Access Compliance Report

Public Rights-of-Way

(Curb Ramps)

Intersection ID: 10040846	Main Street: WAKEFIELD_DR	Cross Street: N/A	Location: S
ADA ID: 394CB7E75316	Ramp Type: PerpDiag	Initial Pass/Fail: Fail	Overall Compliance: No
Severity Score: 10			
Codes/Mitigation Info/Possible Solution		Field Measurements/Component Compliance

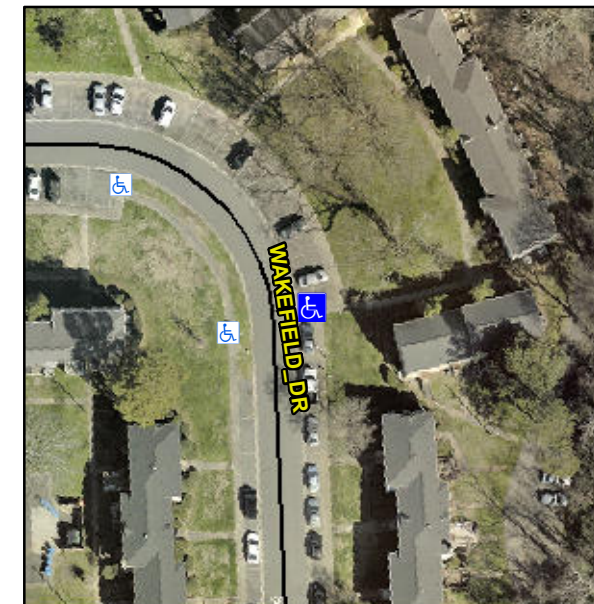
Not Found, R304.5.1, R304.5.3

Compliance	Description	Data	Compliance	Description	Data
N/A	Ramp Length (in)	38.0	Yes	Ramp Slope (%)	6.0
No	Ramp Width (in)	47.0	No	Ramp XSlope (%)	4.1
N/A	Flare Type LT	N/A	N/A	Flare Type RT	N/A
N/A	Flare Slope LT (%)	N/A	N/A	Flare Slope RT (%)	N/A
N/A	Flare Traversable LT?	N/A	N/A	Flare Traversable RT?	N/A
N/A	Landing Length (in)	N/A	N/A	DWS Provided?	N/A
N/A	Landing Width (in)	N/A	N/A	DWS Contrast?	N/A
N/A	Landing Slope (%)	N/A	N/A	DWS Length (in)	N/A
N/A	Landing X Slope (%)	N/A	N/A	DWS Full Width?	N/A
N/A	Landing Curb? (Y/N)	N/A	N/A	DWS Offset (in)	N/A
N/A	Shared Landing?	N/A			
N/A	Gutter Ponding?	N/A	N/A	Gutter Slope (%)	N/A
N/A	Gutter Lip Ht (in)	N/A	N/A	Gutter X Slope (%)	N/A
N/A	Painted X Walk1?	No	N/A	Painted X Walk2?	No
	X Walk 1 Direction	To N		X Walk 2 Direction	To W
N/A	X Walk 1 Width (in)	N/A	N/A	X Walk 2 Width (in)	N/A
	X Walk 1 Slope (%)	1.1		X Walk 2 Slope (%)	4.0
	X Walk 1 X Slope (%)	2.1		X Walk 2 X Slope (%)	0.6

Remove & Replace Curb Ramp With Two New Directional Ramps or Equivalent.
